Town of Pictou

Response to

Northern Pulp Nova Scotia
Focus Report
Replacement Effluent Treatment Facility

Figure 1 Town of Pictou Source Water Protection Committee Delineated Boundary (Town of Pictou, Pictou / Caribou Source Water Protection Plan 2017, NSE webmapping)

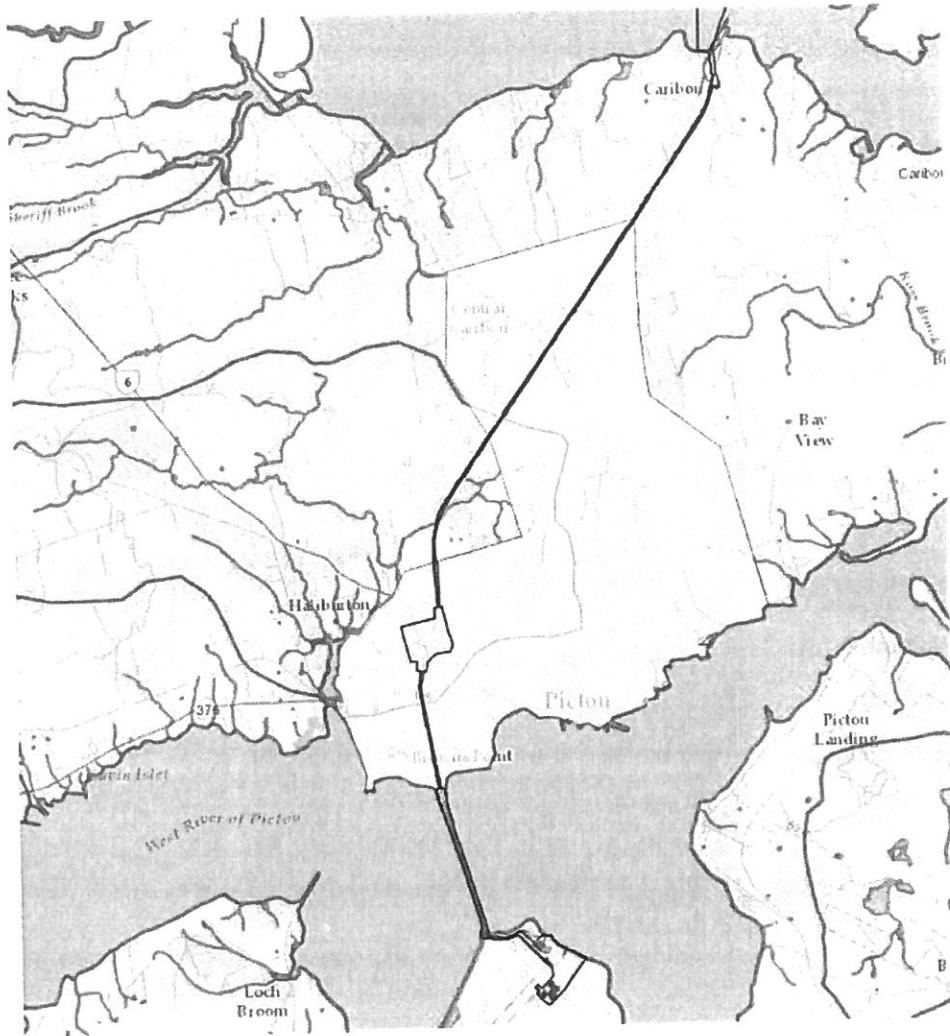
developed a Source Water Protection Plan (latest revision Oct 2017) to address potential risks. Potential risks related to pipeline routing are not specifically addressed. The attached Figure 1 here shows the SWPA delineated boundary. In comparison to Figure 2 (pipeline route also attached) it can be seen the pipeline route along Highway 106 crosses the SWPA delineated boundary in two areas.

5. The registration document from Northern Pulp identifies in Figure 8.5-1 (p. 192) two sets of dashed lines estimating the Pictou and Caribou wellfields extent, and a delineation boundary from the Pictou Source Water Protection Committee (SWPP report). It should be noted that neither of these estimated boundaries represent a strong scientifically valid description of the wellhead protection zones. However they may be useful for planning purposes. Quantitative hydrogeological determination of the well head protection area (WHPA) (numerical computer modelling) showing wellfield zones of contribution and expected times of travel would be beneficial in managing specific risks to the wellfields.

1. The current Source Water Protection Plan for the Town of Pictou includes a conceptual indication of the groundwater zones contributing to the two wellfields and a larger Source Water Protection Area. As a greater protection measure, the Well Head Protection Area (WHPA) zones would be updated by better definition and quantitative (numerical) computer modelling to demonstrate the 0-2 year

Figure 2 Proposed Pipeline Route 500 m radius buffer zone and water wells (NS Groundwater Atlas, Energy and Mines 2019)

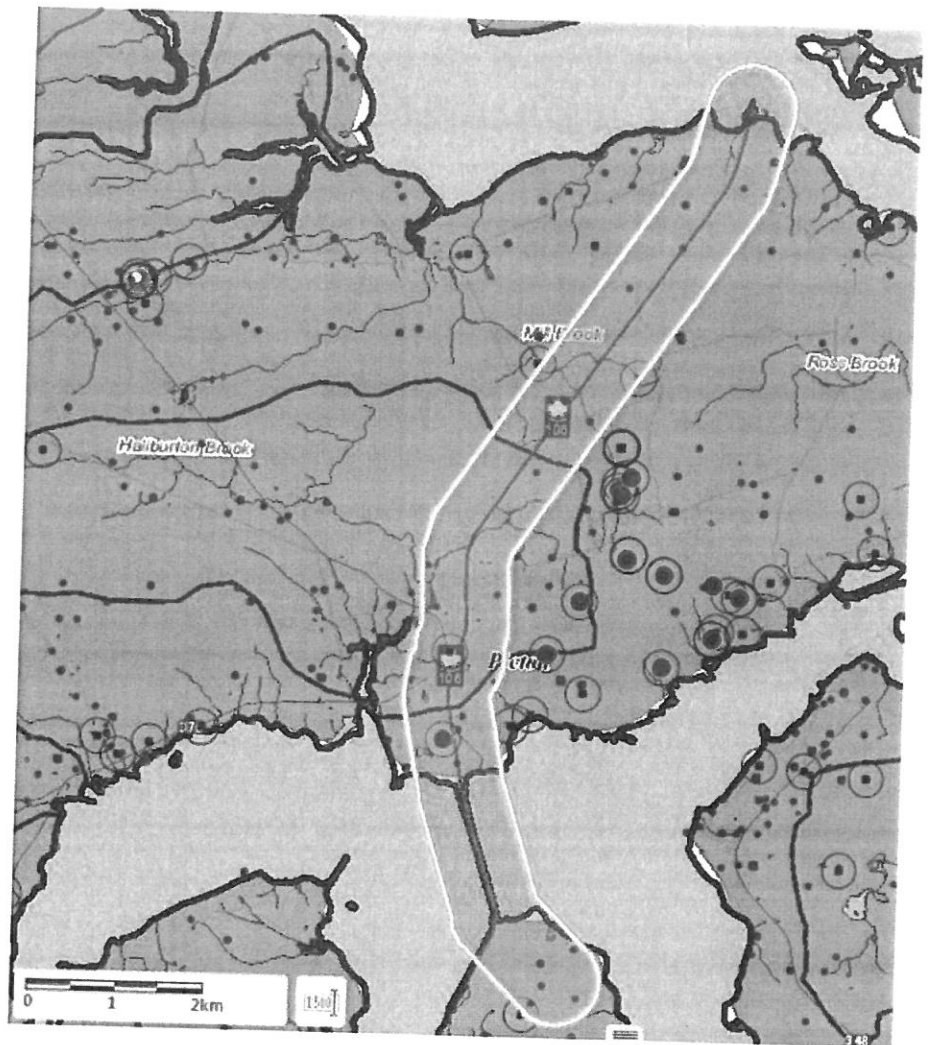
6. The online Nova Scotia Groundwater Atlas (Energy and Mines) was used (by this reviewer) to estimate the number of residential drilled wells within a 500 m radius buffer (on either side) of the proposed pipeline route from the ETF to Caribou. See the attached Figure 2 showing the 500 m buffer zone. The Atlas identified 62 water wells within the 500 m buffer distance. The majority of these are identified as for domestic use, but two are listed as public (non-municipal).
